Environmental Review Team Report

The Town Farm
East Haddam, Connecticut

January 1979

ENVIRONMENTAL REVIEW TEAM REPORT
ON
TOWN FARM SUBDIVISION
EAST HADDAM, CONNECTICUT

Preliminary Subdivision Plan

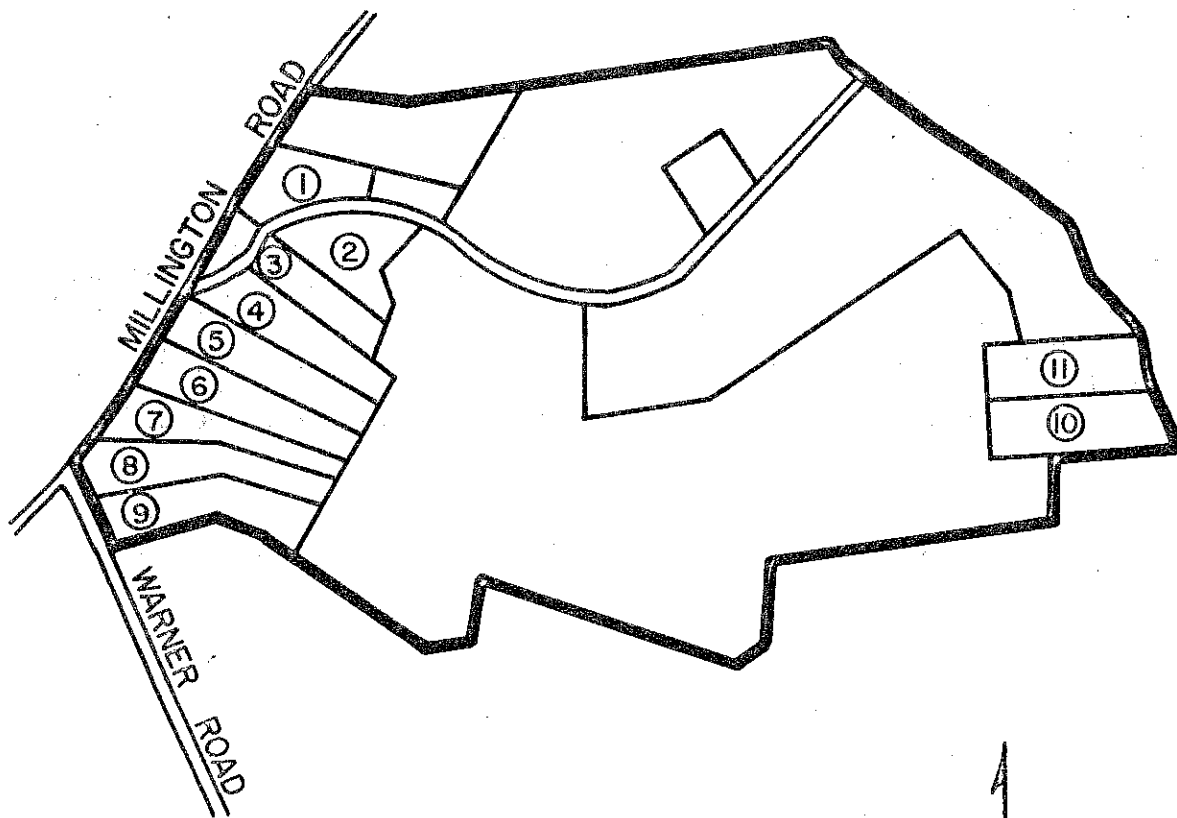
The Team is generally concerned with the effect of this land use on the natural resource base of the site. Preliminary research indicated that the soils on this site have severe limitations for residential development with respect to road construction, septic tank leaching fields and homesite location. A detailed sediment and erosion control plan and a stormwater management plan should be developed and implemented for the site. The subdivision plan should indicate these erosion and sedimentation control measures and should detail drainage and road improvements as recommended by the Town Engineer.

The variable nature of the soils and the presence of steep slopes, bedrock, ledge outcroppings, and boulders may prevent development of some of the lots as proposed. It is recommended that an intensive investigation of soils on each lot be performed to insure that there is an adequate amount of land suitable for traditional residential development or that proposed improvements will be adequate. As an alternative, and if suitable sites can be found, consideration should be given to cluster, larger lots, or other land uses.

Lots 10 and 11 should have detailed soil surveys to clearly delineate the boundaries of the inland-wetland soils.

As percolation tests were conducted in mid-June, the Town sanitarian might wish to retest the lots in traditionally wetter months. Potential problems such as plugged tile lines and effluent backup are elaborated on in the Waste Disposal section of this report. Diversions should be installed above leaching fields and basements proposed on slopes. Each lot viewed on the field inspection appears to need this improvement to some degree. Because of the problems of rock, ledge, slope and wet soils, the Commission and sanitarian might require that the proposed engineered solutions actually be installed to determine whether these recommendations will work. One or two lots might be selected as a model for others.

If the Commission views this section of Oriole Road as a dead end road then the town Subdivision Regulations (Section 4.3) state that it should end in a turning circle of at least a fifty foot radius. The town and Commission policy regarding roads should be reviewed as it effects Oriole Road. The engineer proposes an improved gravel road to serve lots 10 and 11. As Oriole Road slopes in both directions to a low point approximately in the middle of lot 11's front property line, drainage along Oriole Road is and will continue to be of major concern.

The areas not designated for development should be designated as open space, reserved for future development or other land use. This information should be shown on the site plan.

Bedrock Outcrops

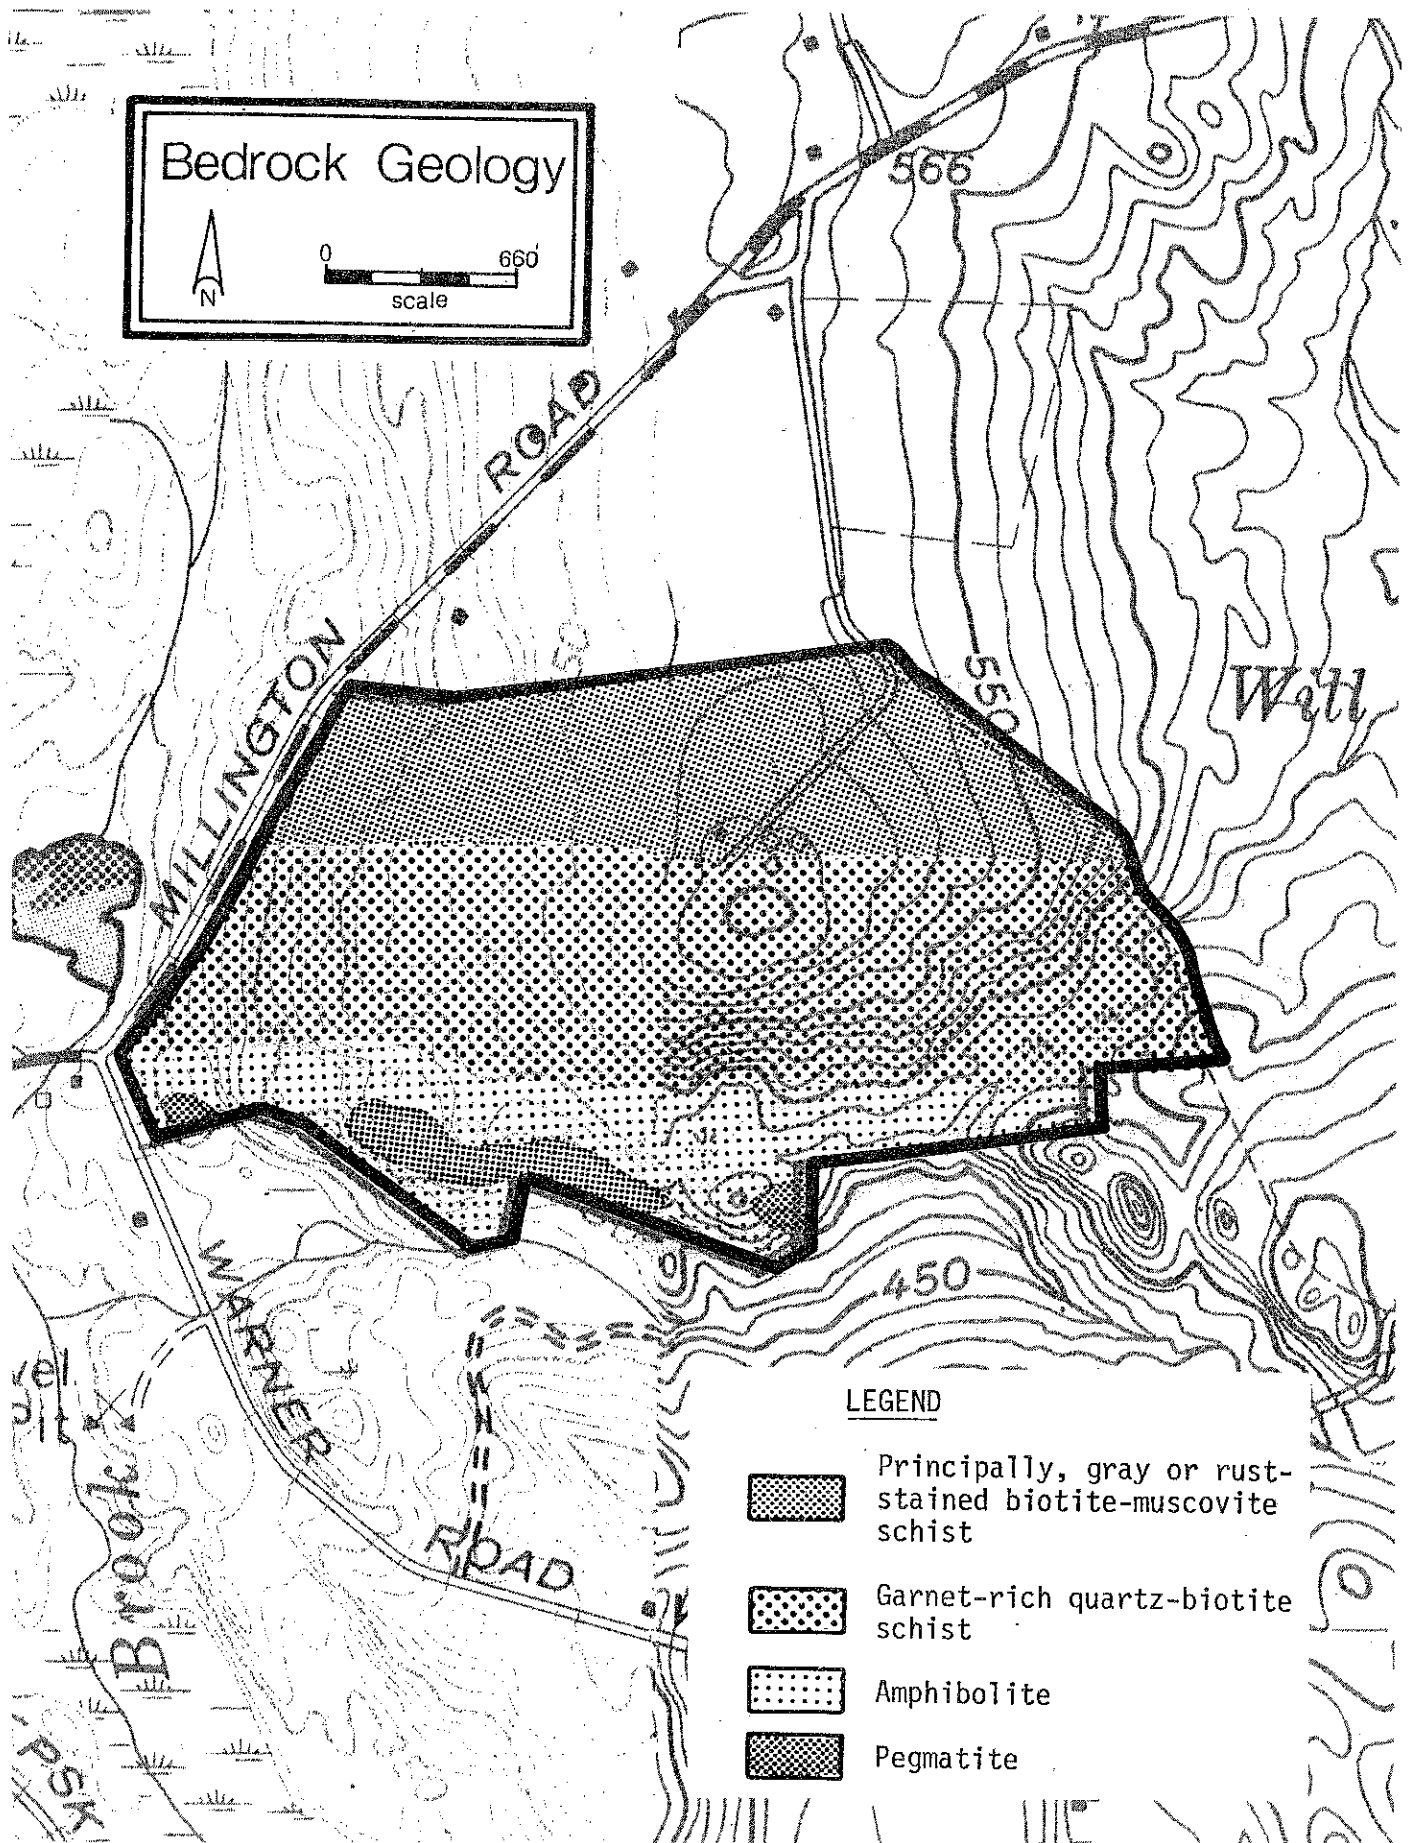
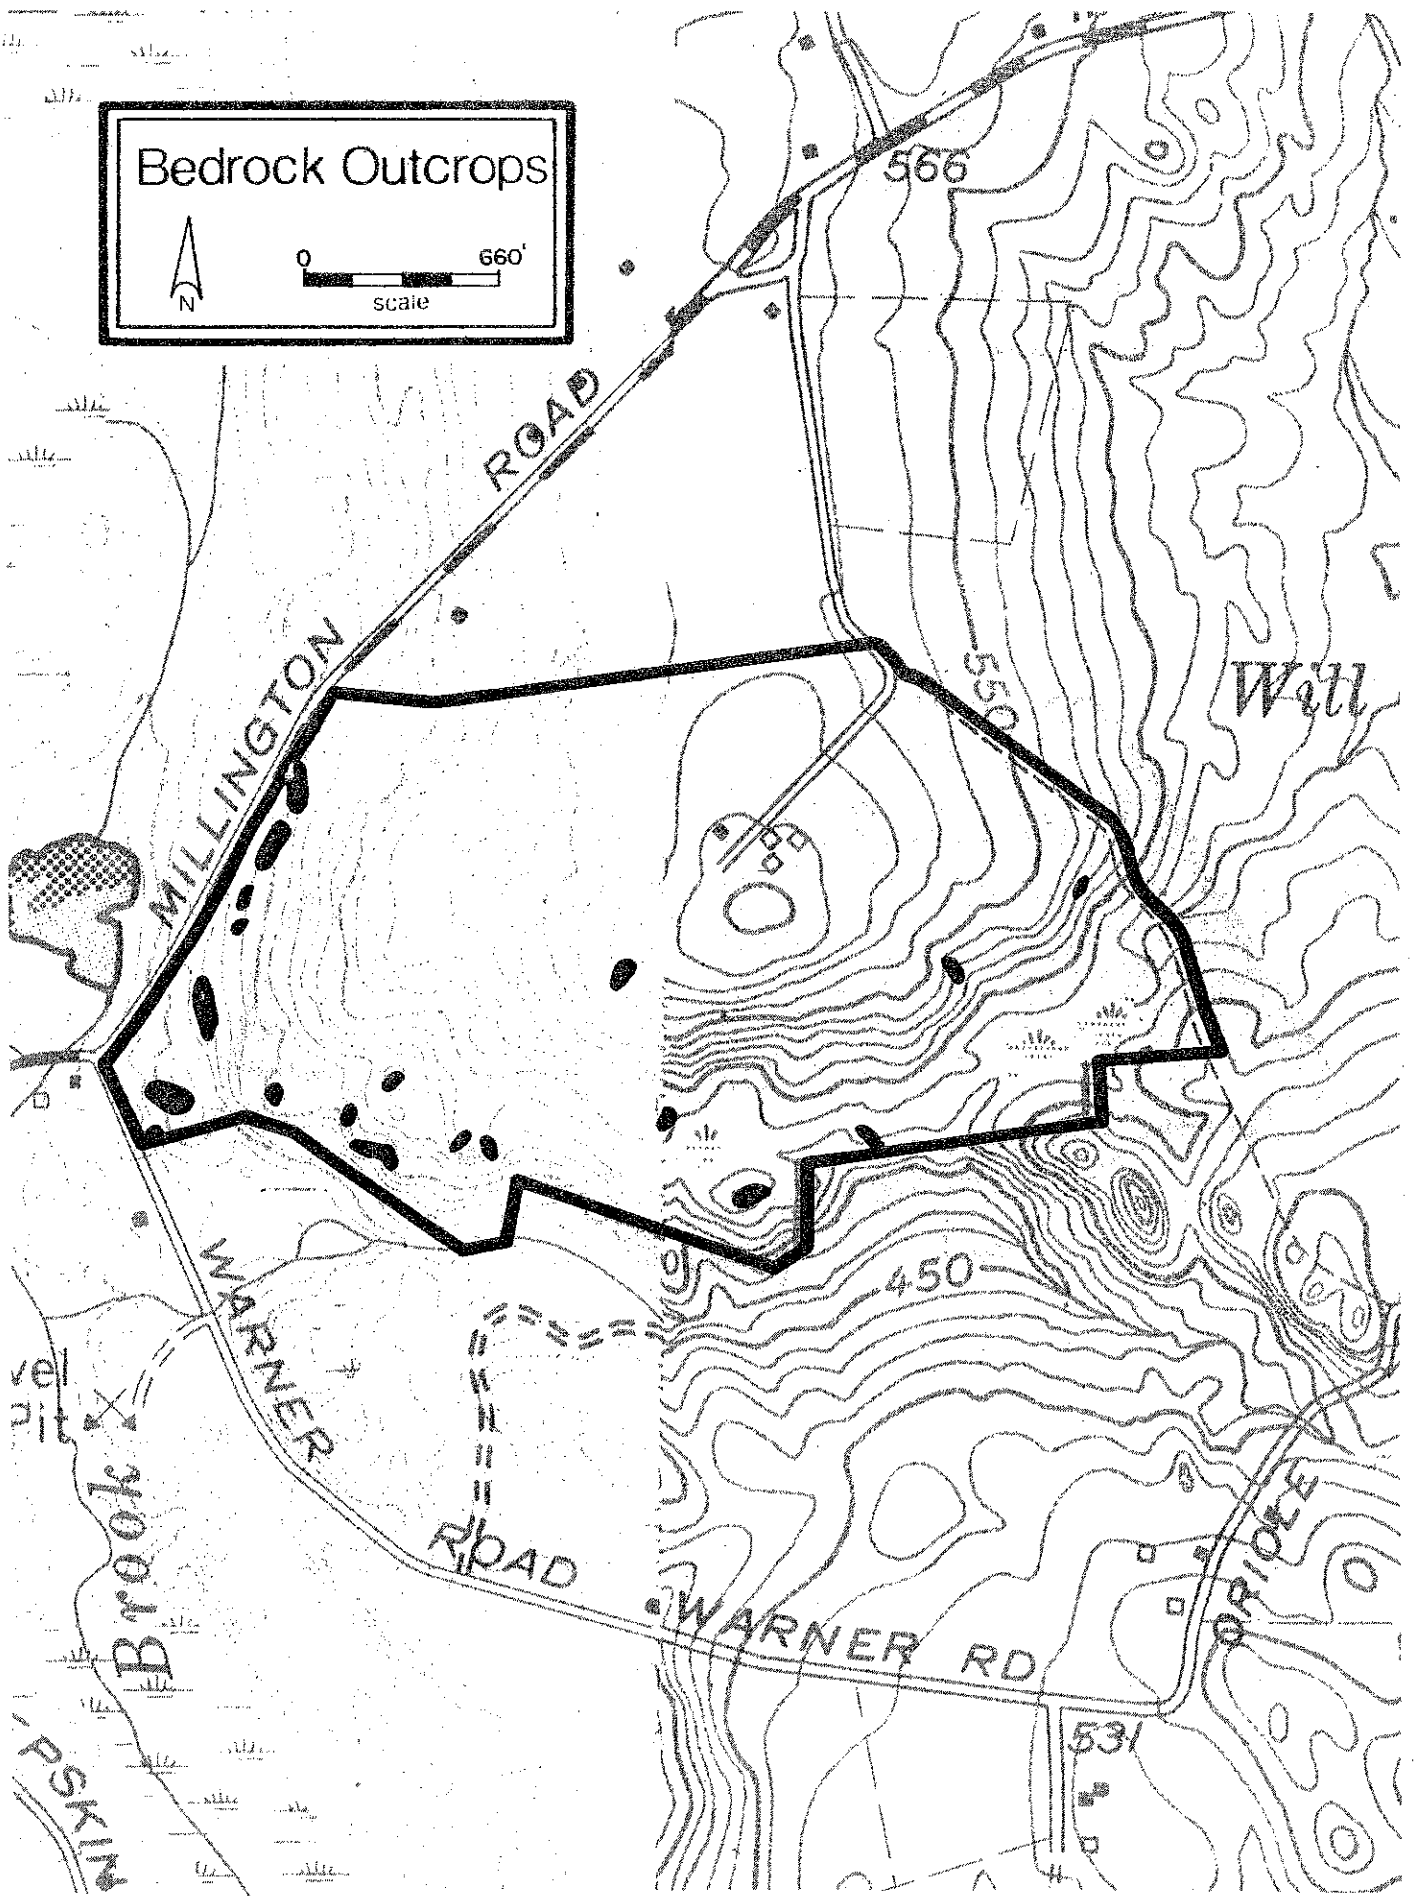
Bedrock on the property is part of a geologic unit known as the Brimfield Formation. Three subdivisions of this unit cross the property in essentially east-west bands (see accompanying figure). The northernmost band comprises interbedded layers of several different rock types. Most of these layers are gray or rust-stained biotite-muscovite schists or schist-like gneisses. (Schists are rocks in which platy or flaky minerals have aligned to form wavy or crinkled surfaces that tend to be easily separated. Gneisses are similar to schists, but they are more granular, contain fewer flaky or platy minerals, and are not easily separated along planes of mineral alignment.) Other rock layers in the northern band are composed of calcium-silicate rocks, quartz-biotite schists, and amphibolite (rock that is rich in the mineral amphibole). The central band is composed largely of amphibolite. The southern band comprises garnet-rich quartz-biotite schist and interbedded amphibolite. Pegmatite, a coarse-grained granitic rock composed largely of quartz, feldspar, and mica, intrudes all the bands, but it has been mapped only where relatively extensive.

The layering of the schists dips north-northeast, and the largest fractures in the rock appear to follow this layering. The significance of this structural feature is discussed in the section on Water Supply. Further information about the bedrock on the property may be found in Quadrangle Reports Nos. 13 and 19 of the Connecticut Geological and Natural History Survey.

VEGETATION TYPES*

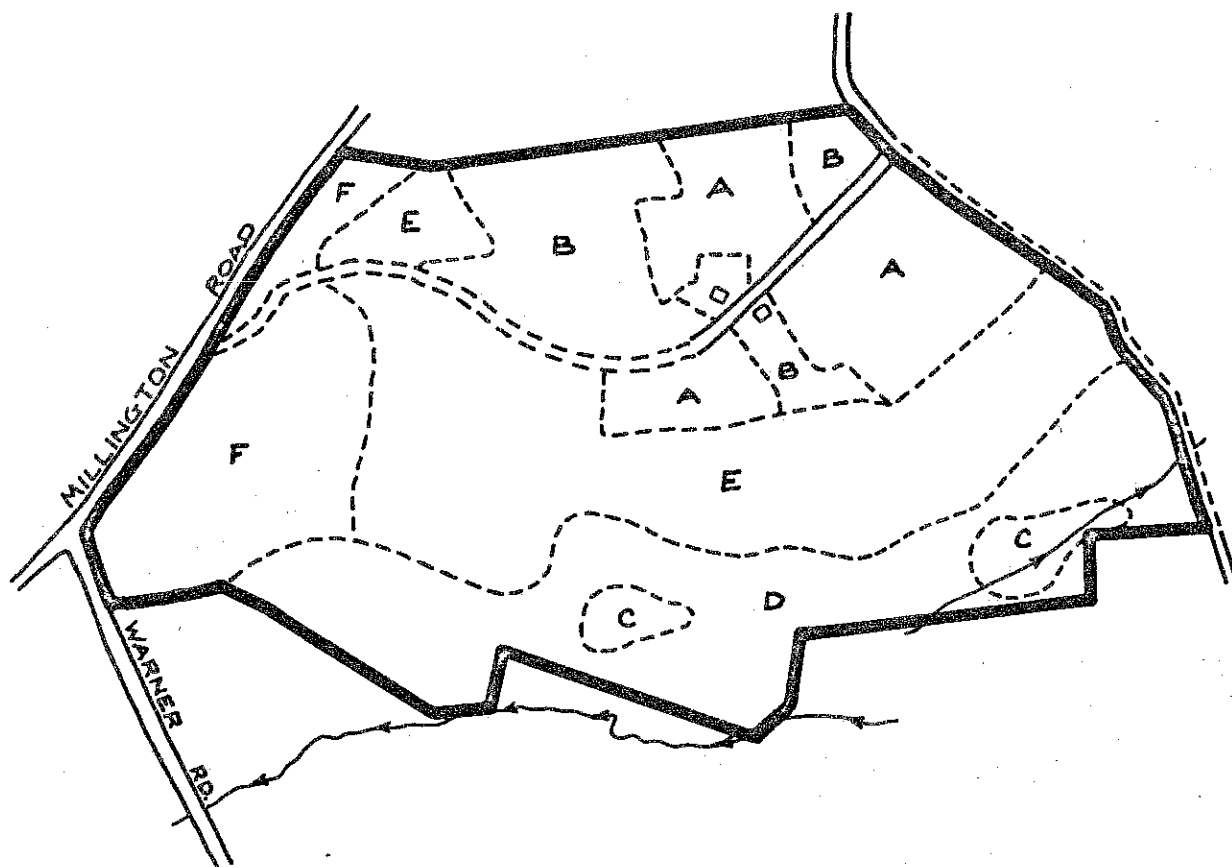
At present the preliminary plans for the "Town Farm" calls for the development of approximately 22 acres of the total 117 acre tract. The entire area is forested except 17 acres of hayfields. The tract is divided into six vegetation types. These types reflect the differences in successional development from time of abandonment as cultivated fields. (See Vegetation Map).

Construction of driveways, buildings, and septic fields will demand cuts and fills due to the steeply sloped and rocky nature of this site. Trees which are damaged by such construction or have the soil disturbed under their crowns should be removed. A high risk of mortality may last as long as three years for these trees.

The mature white oak trees over 24 inches DBH with the large dead limbs are unhealthy and should be removed. Only the healthiest trees should be left for wildlife dens or aesthetic appeal, as all others will prove to be liabilities to the individual lot owners.

To increase landscape variety for aesthetics or wildlife habitat, any combination of hemlock, white pine, or larch would be suitable if planted in the open fields at least eight to ten feet apart. If these mowing lots are not maintained, sugar maple, white ash, tulip tree, and red maple will probably become established, as these species are present along the edges of the fields.
